**ASSESSMENT REPORT**

**DOCKET NO. 72-21**

**U.S. DEPARTMENT OF ENERGY**

**TOPICAL SAFETY ANALYSIS REPORT  
FOR THE CENTRALIZED INTERIM STORAGE  
FACILITY**

Figure 3-1. Centralized Interim Storage Facility (CISF) site plan (based on Figure 4.1-1 of the CISF Topical Safety Analysis Report)

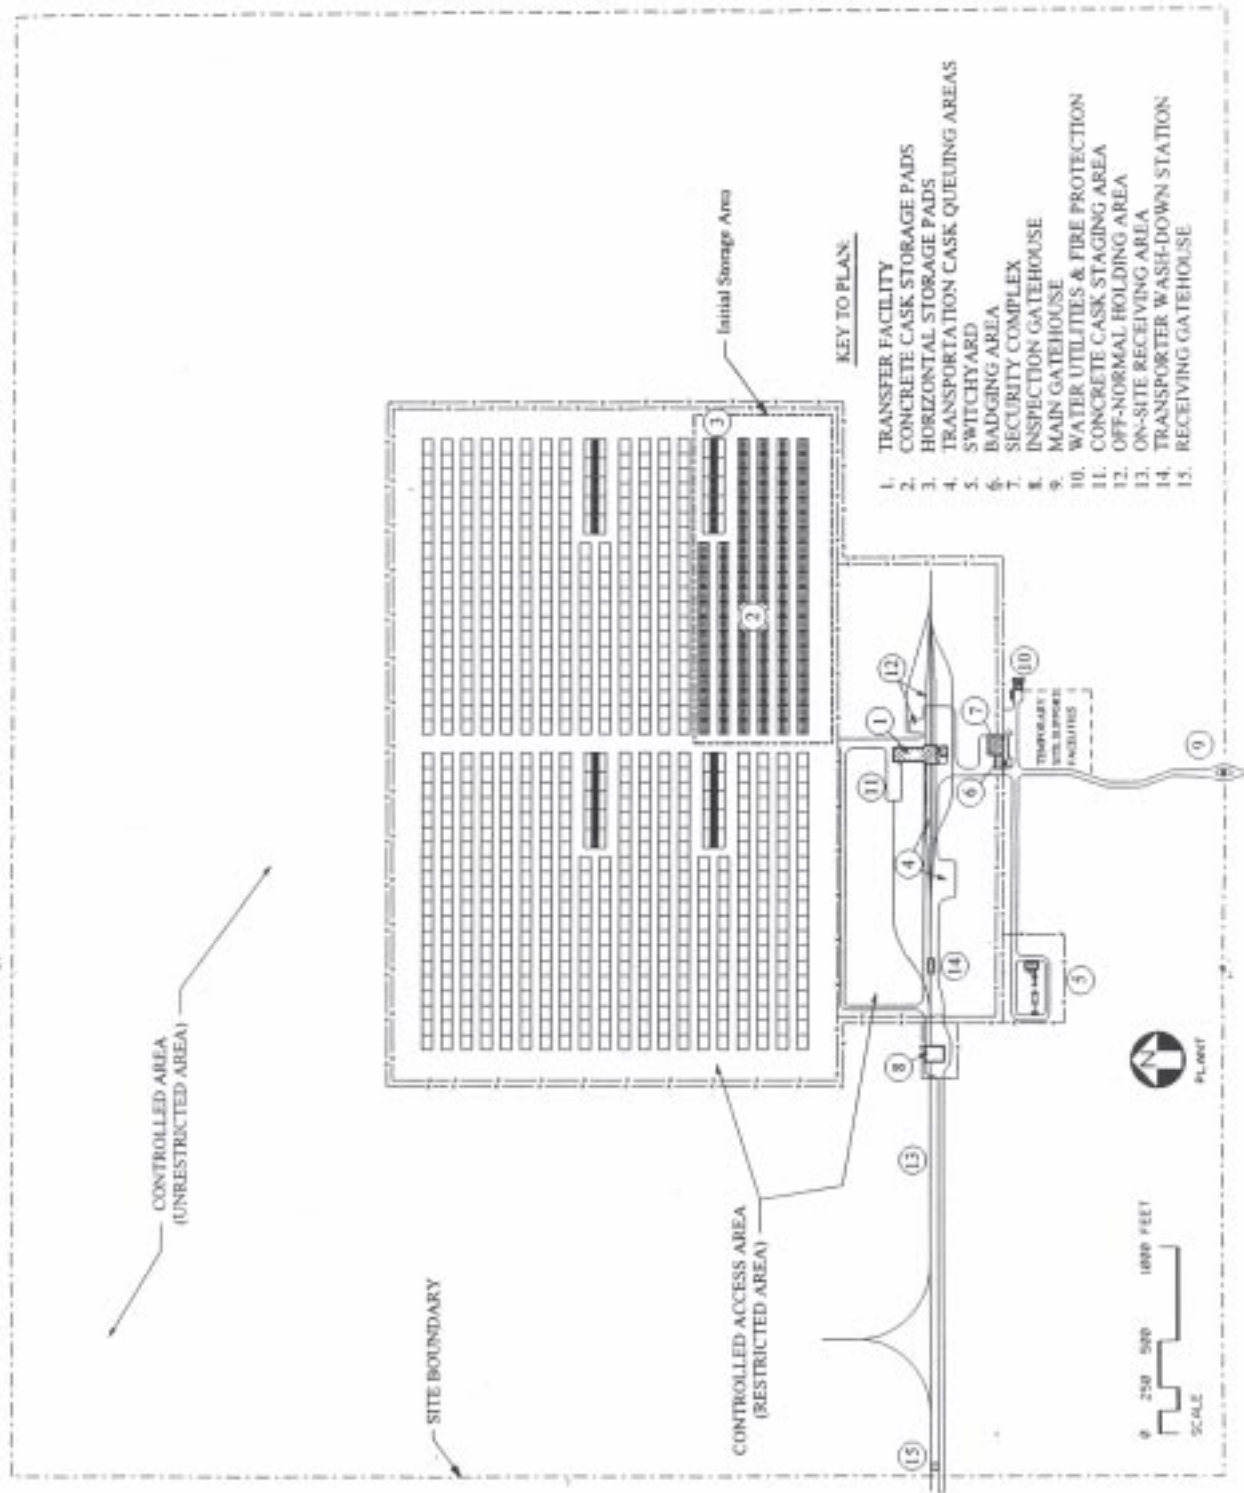
Section 4.1, Installation Design, of the CISF TSAR (U.S. Department of Energy, 1998a) provides a description of the CISF layout and the major buildings, structures, and SNF storage areas (see Figure 3-1). The major functions to be performed at the CISF during the operational period are also identified. The layout of the CISF installation will be based on the generic site characteristics presented in Chapter 2, Site Characteristics, of the CISF TSAR, which are intended to envelop as much of the 48 contiguous United States as is practical. The principal CISF installation features that were summarily described included (i) site boundary, (ii) controlled area, (iii) controlled access area, (iv) switchyard, (v) security complex, (vi) main gatehouse, (vii) water utilities and fire protection, (viii) concrete cask staging area, (ix) receiving gatehouse, (x) on-site receiving area, (xi) inspection gatehouse, (xii) transporter wash-down station, (xiii) transportation cask queuing areas, (xiv) transfer facility, (xv) off-normal holding area, (xvi) storage area and concrete storage pads, (xvii) communications and alarms, (xviii) storage tanks, and (xix) temporary facilities. No stacks will be used at the CISF. The exhaust vent for the transfer facility ventilation system will be located on the side of the transfer facility building.
